**RE: Sundance Construction Beverly Hills Ave NE**

This letter is a request for preliminary question, review and comment on the conceptual Site Plan. This request was recommended by PRT Chairperson Carmen Marrone at a Pre-Application Review Team Meeting (PA #17-142) held on September 26, 2017.

# PRE-APPLICATION REVIEW TEAM (PRT) MEETING

PA# 17-142 Date: 9/26/2017 Time: 2:00 PM

**A1** SITE PLAN  
SCALE: 1" = 20'

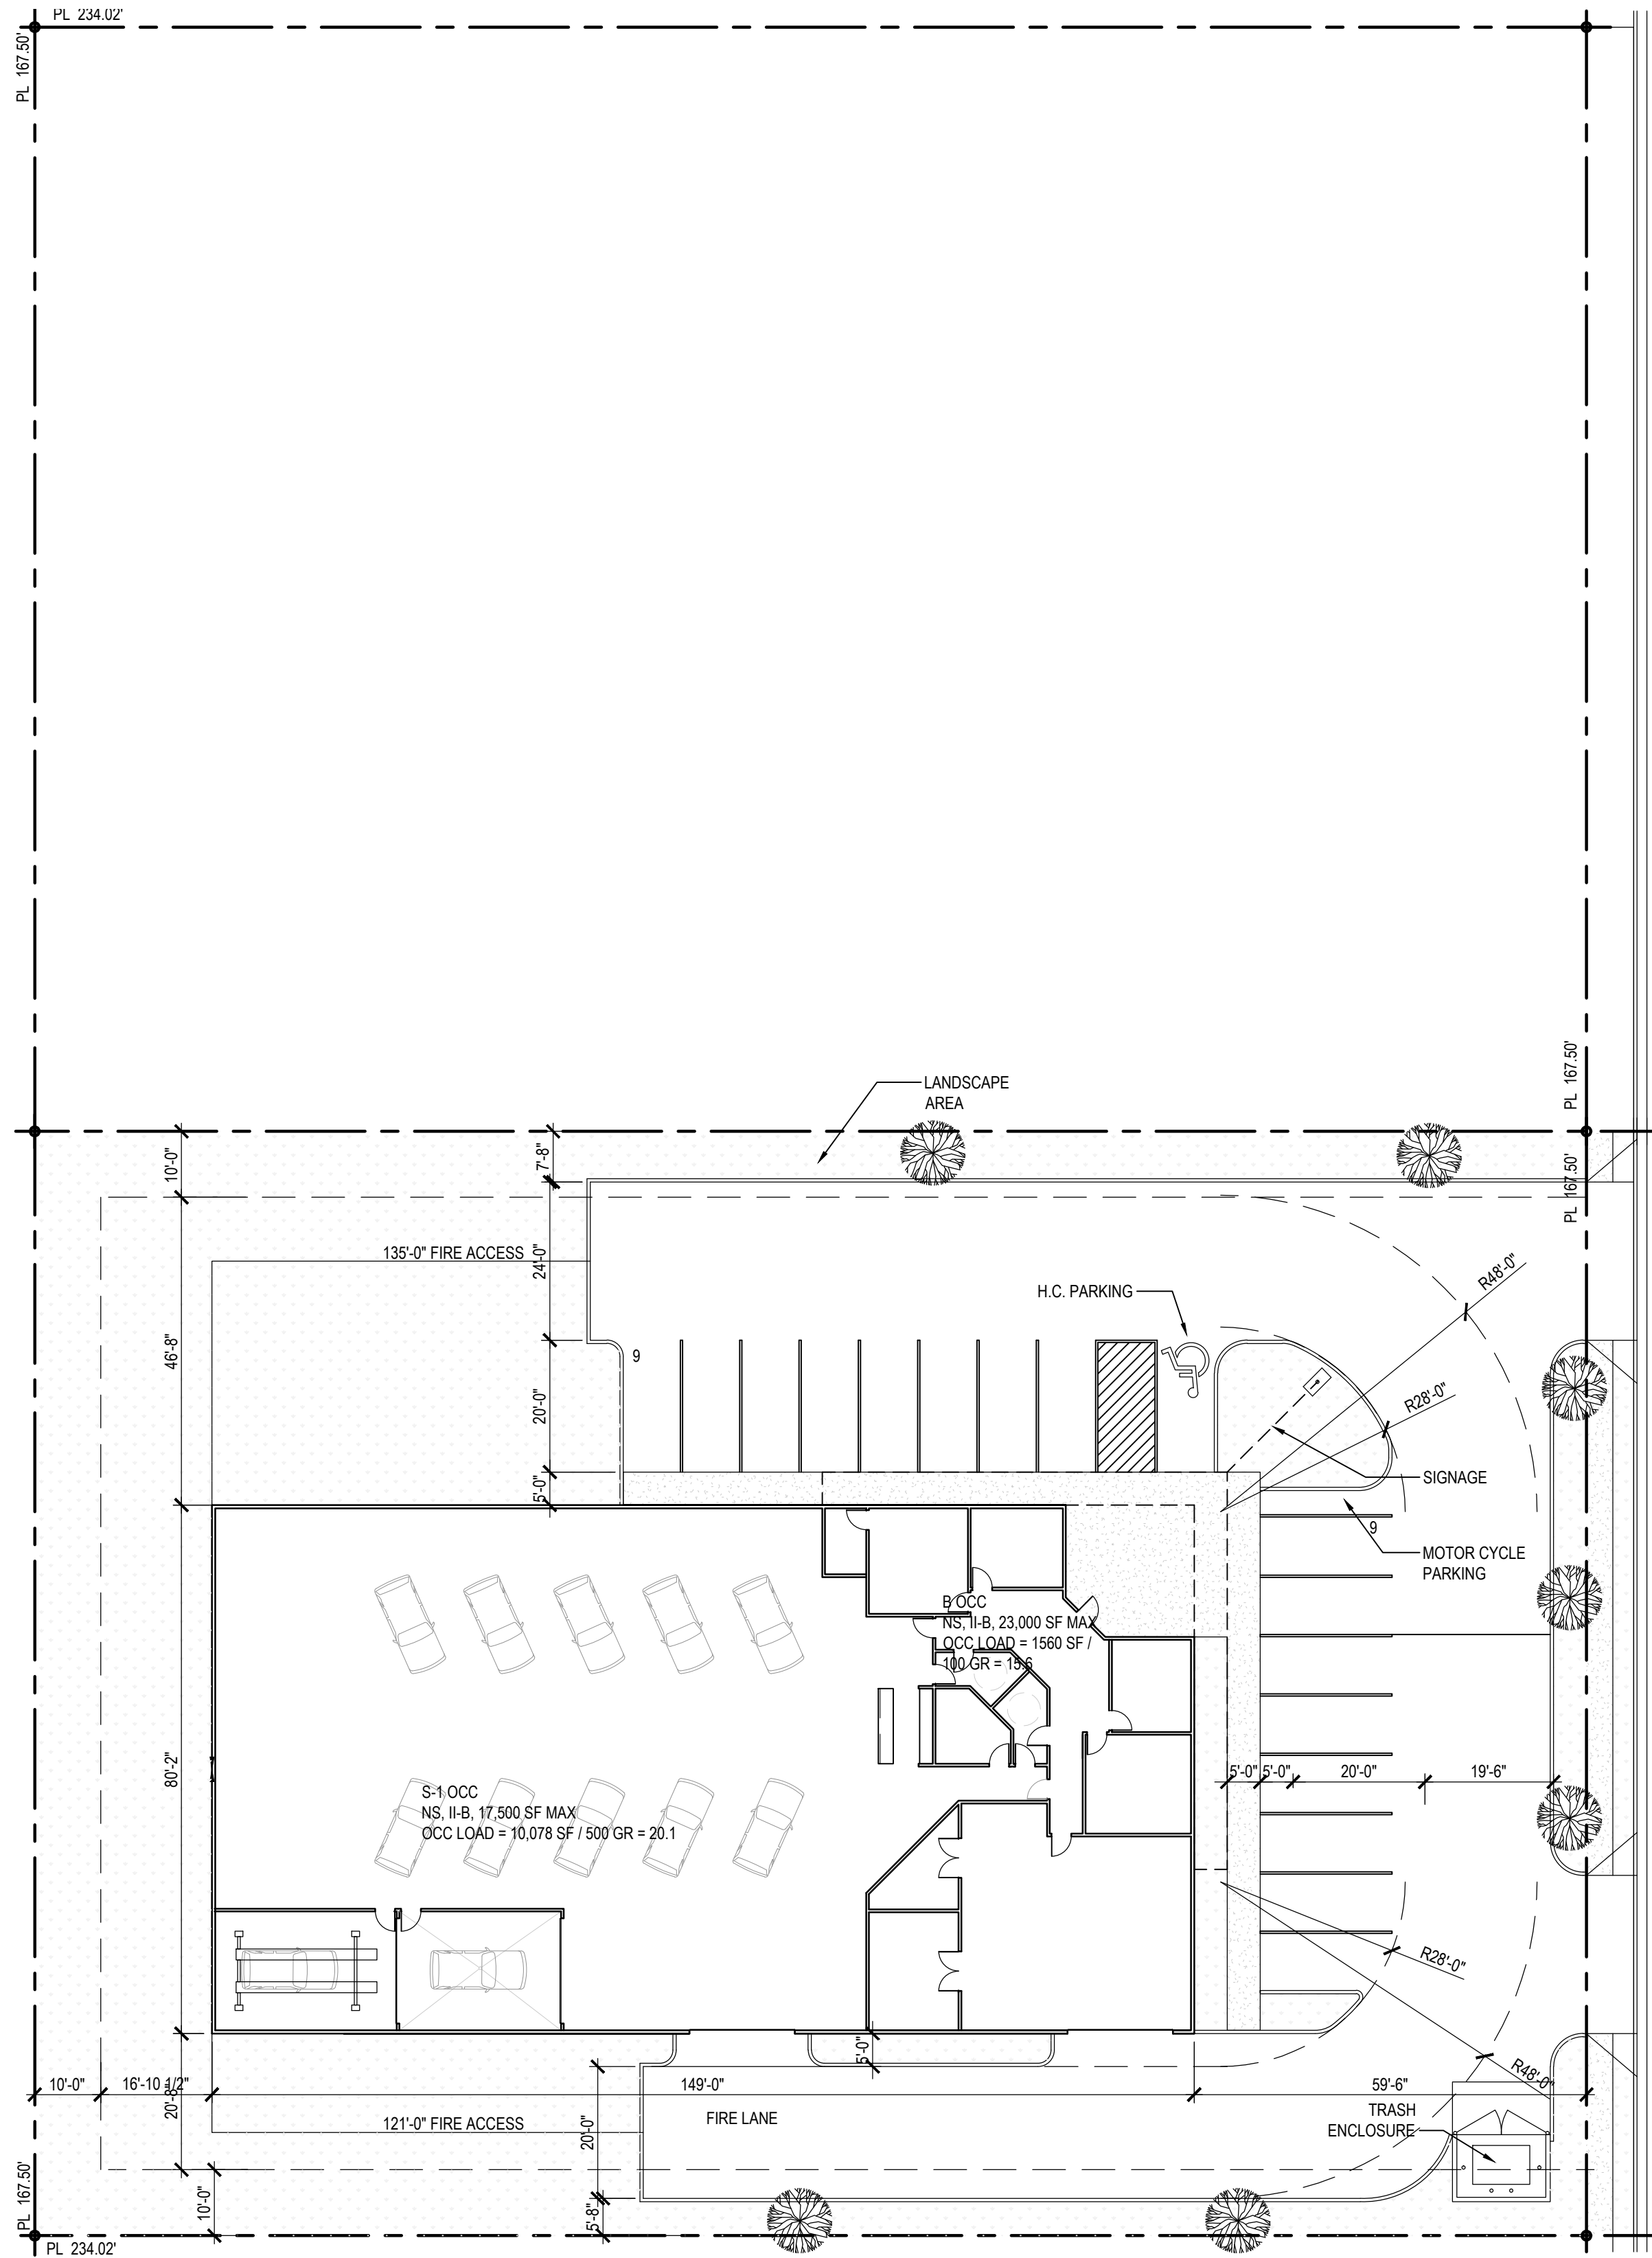
FM. MUST REACH 150' FROM ANY DIRECTION -  
DEADEND CAN NOT BE > 150'  
NOT SPRINKLED.

CONSTRUCTION TYPE - 2B } NEED  
10,078 SF BLDG } 2 HYDRANTS.

SUBMIT FIRE PLAN

BEVERLY HILLS - NOT BUILT. REQUIRES IL THRU DRB.  
HOW MUCH REQ'D - DRB SKETCH PLAN.

PARKING LOT LANDSCAPING - 1 @ 10 SPACES. NO SPACE  
FURTHER THAN 100' FROM TRUNK.

REQUEST H2O / SEWER AVAILABILITY.
